Letter of Response

**RE: 35-41 Wilfred Barrett Dr, THE ENTRANCE NORTH NSW 2261
Development Application DA/308/2011**

We refer to the comments from the JRPP meeting dated 17 May 2012. We have since tested a few design options in response to issues raised by the JRPP and we have had a meeting with Wyong Council on 20th June 2012 to discuss the best design outcome. This letter accompanies the revised architectural plans Issue E.

on 21st June: Ground Floor Plan

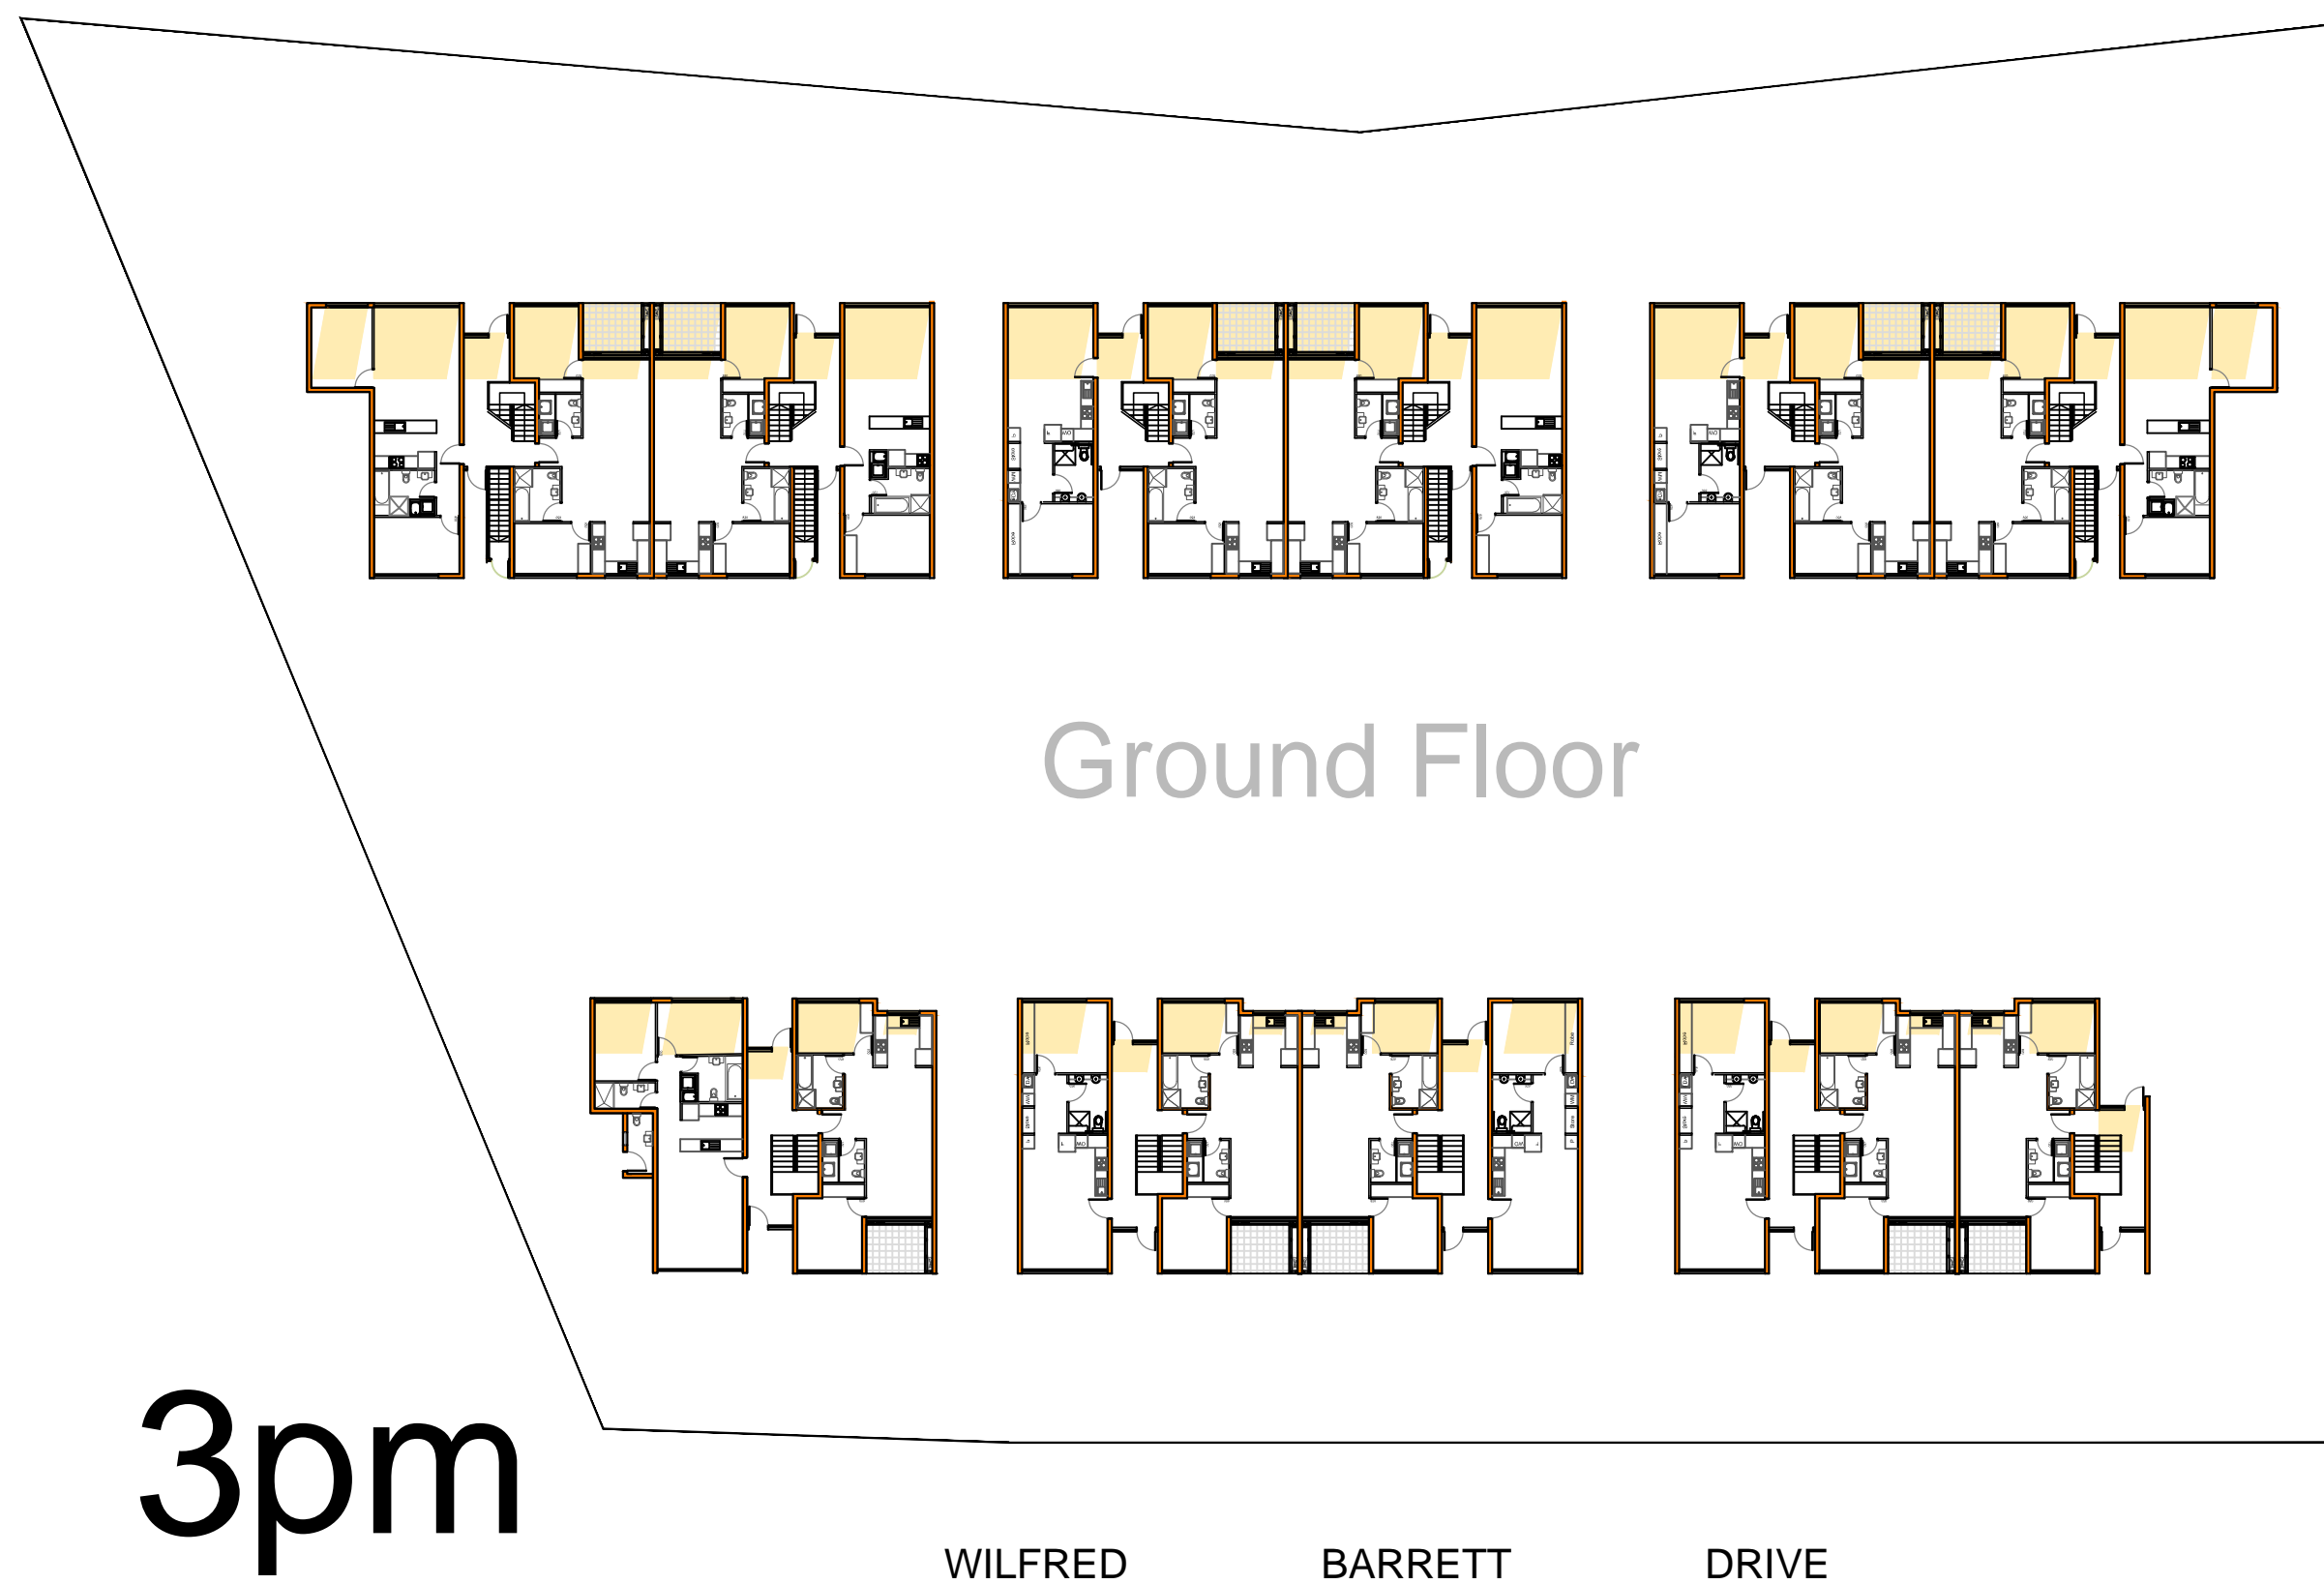
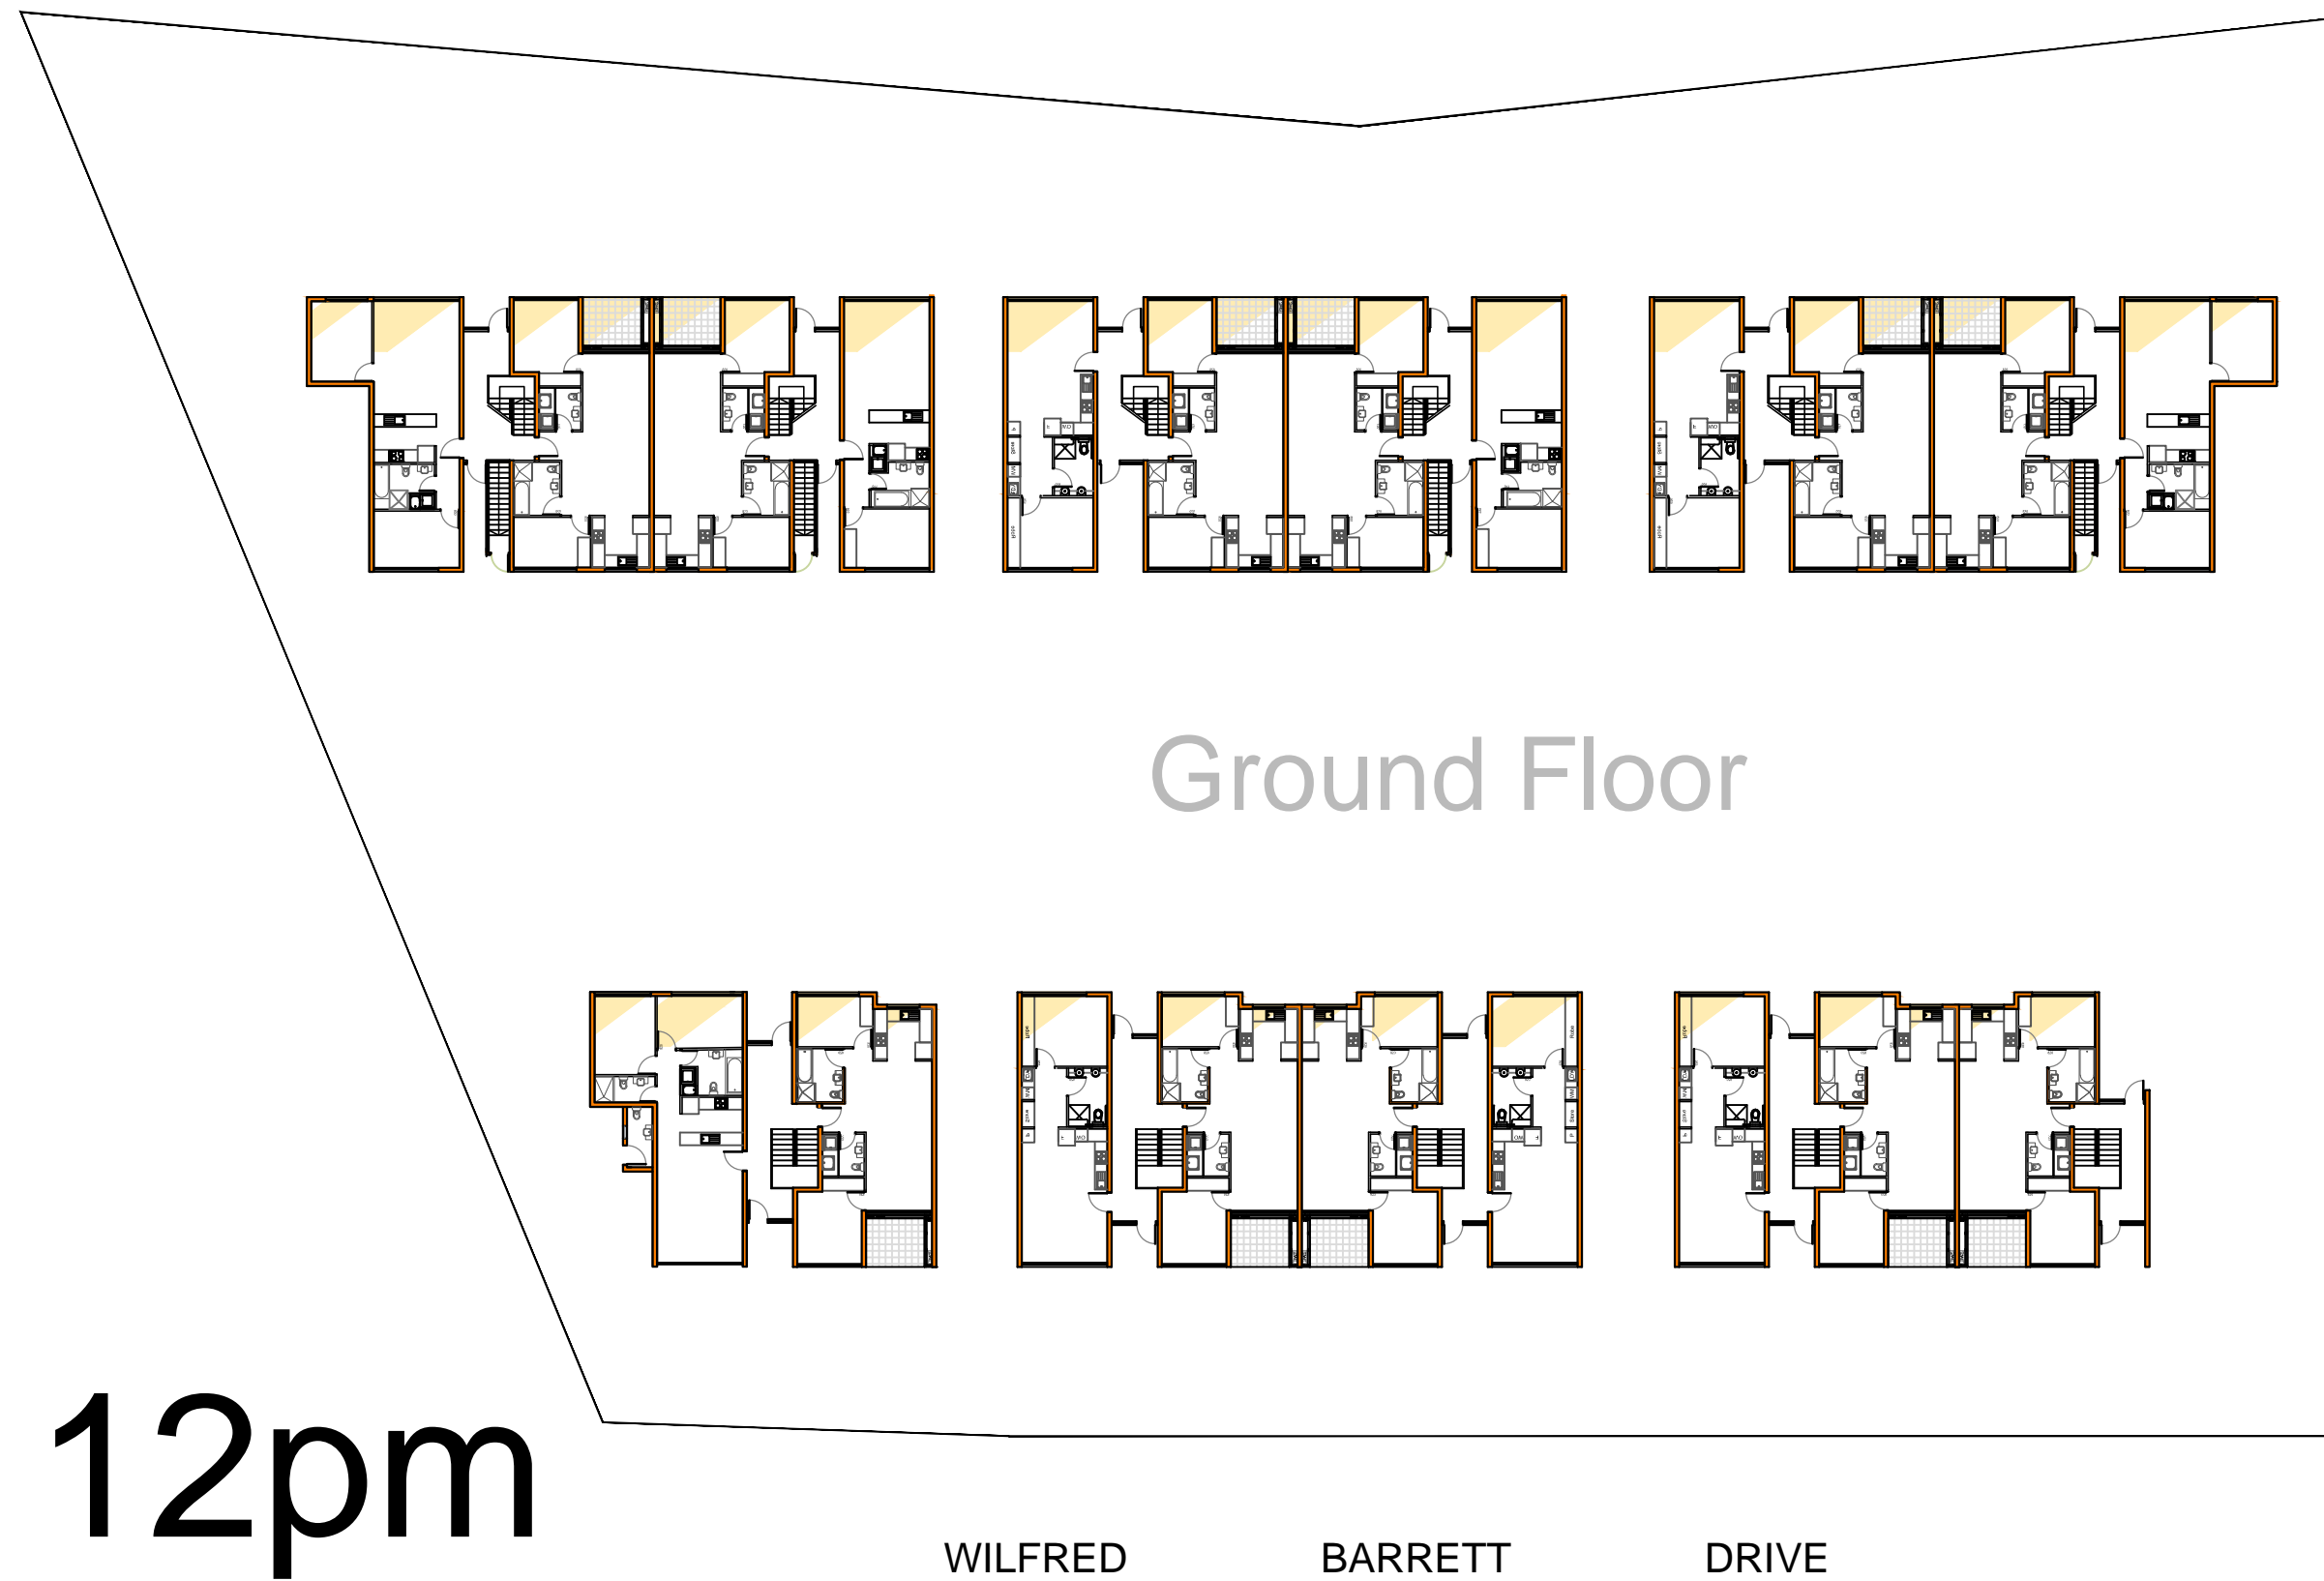
In response to the solar access concern, we have tested 2 alternative design options to increase solar access into units.

Option 2- addition of skylights for all level 1 units. This design option achieves a 79% 3hr solar access into living spaces and private open spaces (exceeding the minimum requirement of 70%). It maintains the initial design proposal of having living spaces and private open spaces of street-front units overlooking the street. By having the living spaces and private open spaces fronting the street will also increase the value of the unit because it is in the aspect of the ocean views. This option not only provides a better amenity, it also enhances passive surveillance to the street (*refer appendix 3 for table of solar access analysis*).

In comparison of the above options, we have concluded that option 2 will be a much better design outcome for the development.
